Response to Public Works Comment 5:

5. *Provide downstream analysis for the stormwater discharging to the Pleasant Bay Road ditch and beyond to Pleasant Bay.*

FIGURE 1
 DOWNSTREAM DITCH
 GOVERNORS POINT
 1-9-2020

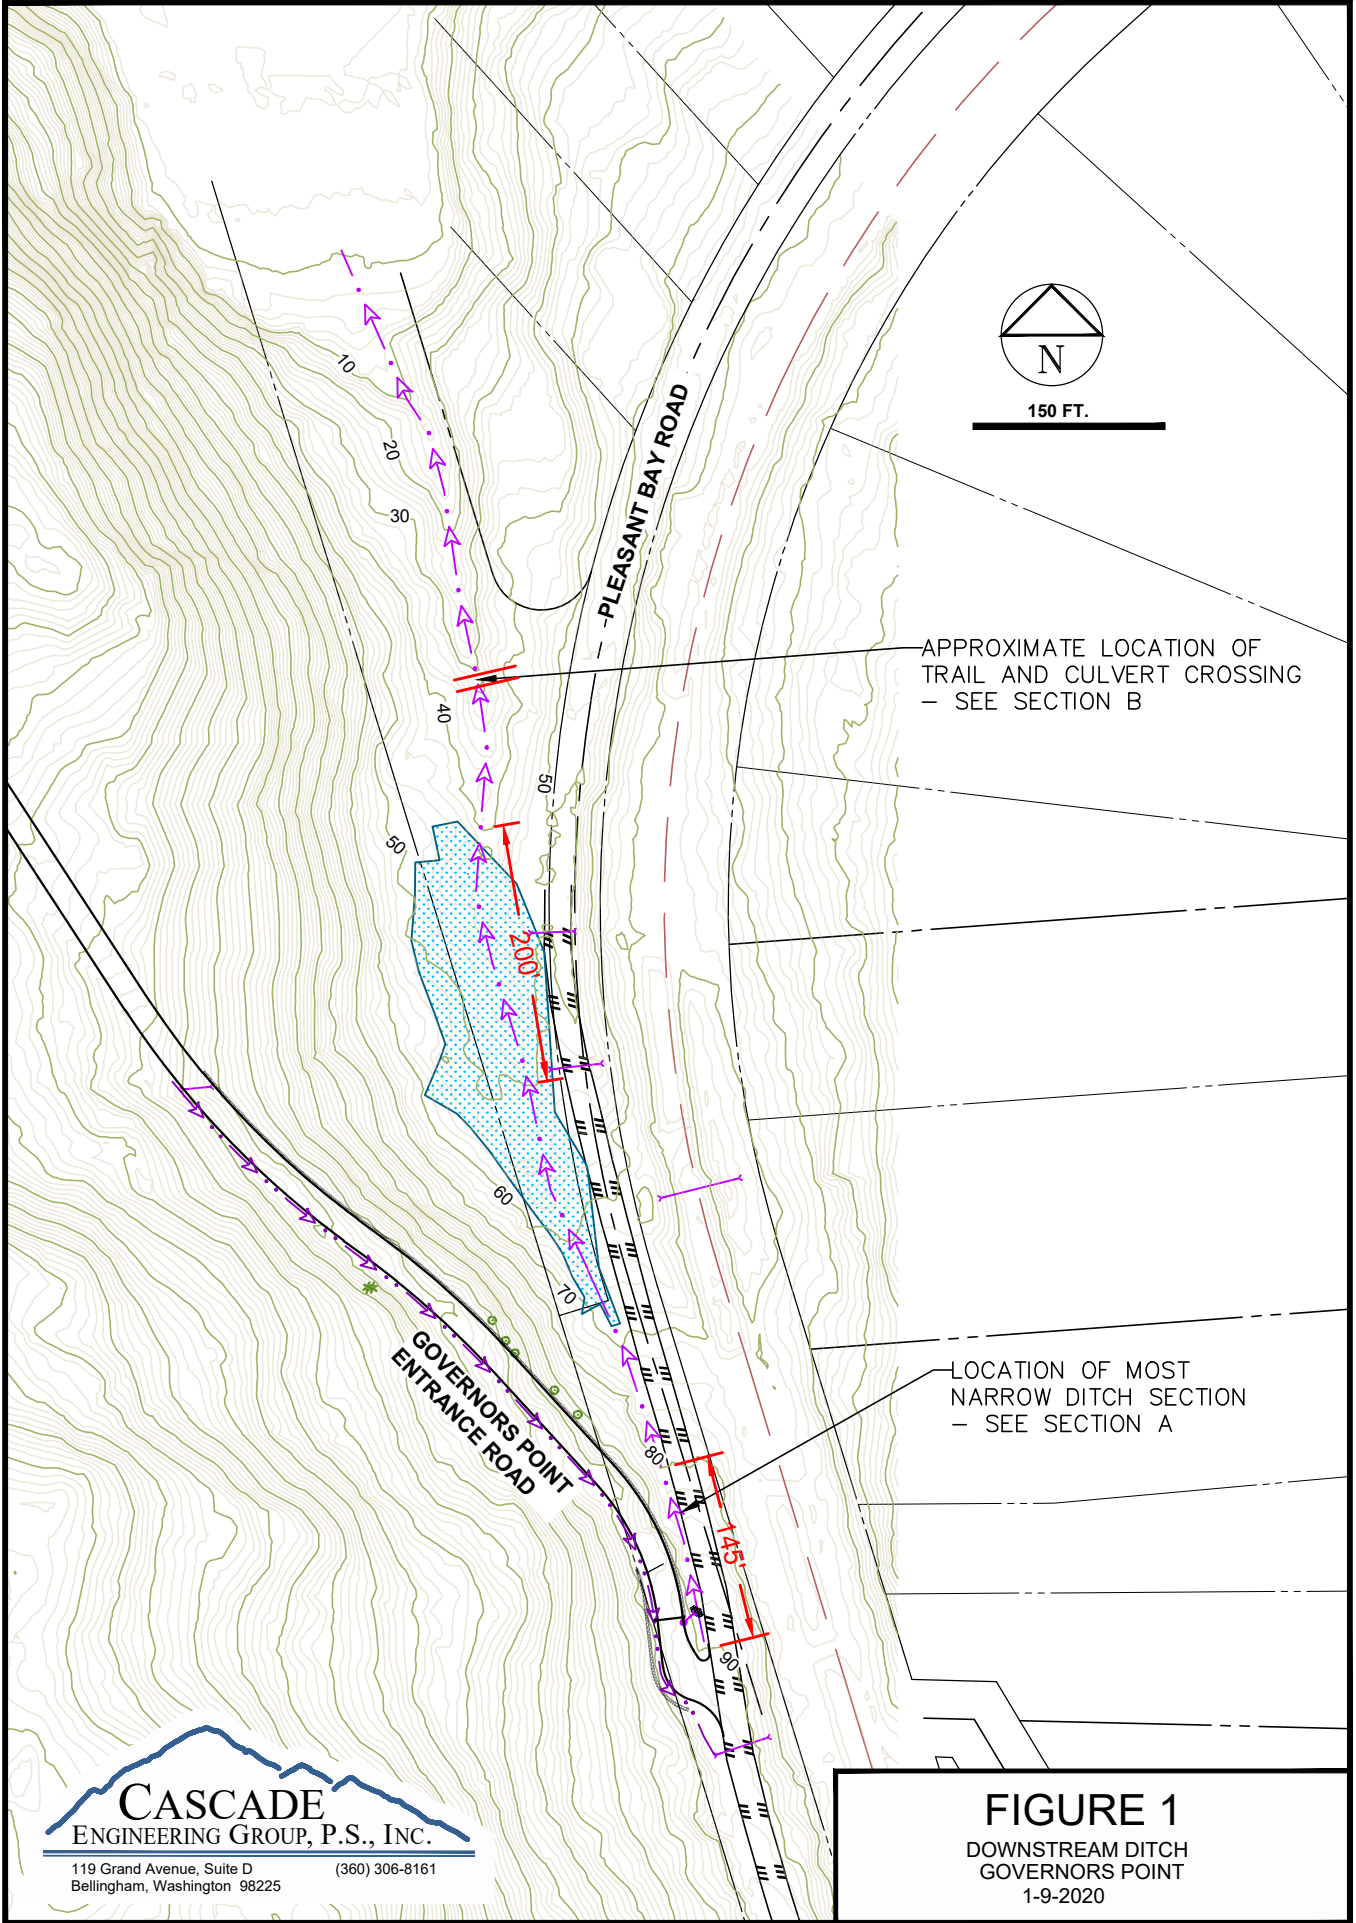
Downstream analysis was provided, however not sufficiently addressed. Consultant to provide an exhibit for the area in question to accompany narrative. Address capacity and condition of the downstream culvert and ditch.

Figure 3: *Cross Culvert Basins*, provided in our October 23, 2019 response to the August 14, 2019 NOAR, shows the locations of the stormwater discharge points and roadside ditches along Pleasant Bay Road. Figure 1, *Downstream Ditch*, of this (January 9, 2020) response shows a more detailed plan view of the Pleasant Bay Road ditch.

The proposed project will not redirected any new runoff to the Pleasant Bay Road ditch. The only change in the runoff to this ditch will be for the conversion of the site's gravel road to a paved road for the section of Road A-South from Sta. 1+00 to Sta 12+00. As stated in our previous response, a WWHM analysis was performed for this 585 ft section of road and a flow rate of 0.20 cfs was estimated for the 100-year developed flow. While this is not new runoff, for the sake of this ditch analysis we will conservatively assume that this 0.2 cfs flow is added to any existing background flow.

Two areas were identified as representative for evaluating the ditch. The first location, identified as Section A in Figure 1, shows the narrowest section of the ditch. At this location the ditch is "V" shaped, approximately three feet wide, one foot deep, and has an approximate slope of 7%. The second location is at the ditch's trail crossing. The ditch has a four foot wide flat bottom, is approximately 3.5 feet deep to the top of the trail, and has an approximate slope of 5%. Figure 2, *Typical Ditch Cross Sections*, provides details of these two ditch sections.
